Access Compliance Report Public Rights-of-Way (Curb Ramps)

Main Street: BUSHWOOD_CIR Cross Street: WEGEFORD_RD Location: E

ADA ID: RPRK211104135926 Ramp Type: Type 4 - Parallel Initial Pass/Fail: Fail Overall Compliance: No Severity Score: 16

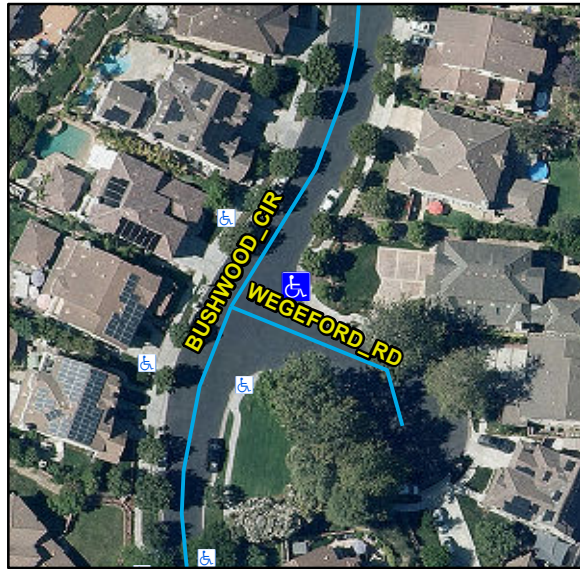
Compliance	Description	Data	Compliance	Description	Data
N/A	Ramp Length LT (in)	113	N/A	Ramp Length RT (in)	116
Yes	Ramp Width LT (in)	53	Yes	Ramp Width RT (in)	53
No	Ramp Run Slope LT (%)	11.7	Yes	Ramp Run Slope RT (%)	1.9
No	Ramp Cross Slope LT (%)	2.6	No	Ramp Cross Slope RT (%)	2.5
N/A	Landing Present	N/A	N/A	DWS Provided	N/A
N/A	Landing Length (in)	N/A	N/A	DWS Contrast	N/A
N/A	Landing Width (in)	N/A	N/A	DWS Length (in)	N/A
N/A	Landing Run Slope (%)	N/A	N/A	DWS Full Width	N/A
N/A	Landing Cross Slope (%)	N/A		DWS Offset Type	N/A
N/A	Landing Movement Obstructed?	N/A	N/A	DWS Offset Left (in)	N/A
	Landing Movement Type	N/A	N/A	DWS Offset Right (in)	N/A
N/A	Landing Shared	N/A			
N/A	Clear Space	Yes			
N/A	Clear Space To Crosswalk (in)	N/A			
N/A	Marked Crosswalk 1	No	N/A	Marked Crosswalk 2	No
	Crossing 1 Direction	NW		Crossing 2 Direction	SW
	Marked Crosswalk 1 Width (in)	N/A		Marked Crosswalk 2 Width (in)	N/A

N/A	Ramp Inside Crosswalk 1	N/A	N/A	Ramp Inside Crosswalk 2	N/A
	Crossing 1 Slope (%)	3		Crossing 2 Slope (%)	0.2
	Crossing 1 Cross Slope (%)	5		Crossing 2 Cross Slope (%)	2.6
N/A	Gutter Ponding	N/A	N/A	Curb Slope	10.3
Yes	Gutter Lip Height (in)	0		Road Run Slope (%)	2.8
N/A	Gutter Run Slope (%)	N/A		Road Cross Slope (%)	0.2
N/A	Gutter Cross Slope (%)	N/A	No	Perpendicular Joint Present	No
Yes	Overall Surface Condition	Acceptable			
	Cross Gutter Present?	No		Spandrel Present?	No
	Replace Cross Gutter?	N/A		Replace Spandrel?	N/A

Remove & Replace Curb Ramp With Two New Directional Ramps or Equivalent.

R204.3, R304.3.2, R304.5.3, STD 1115
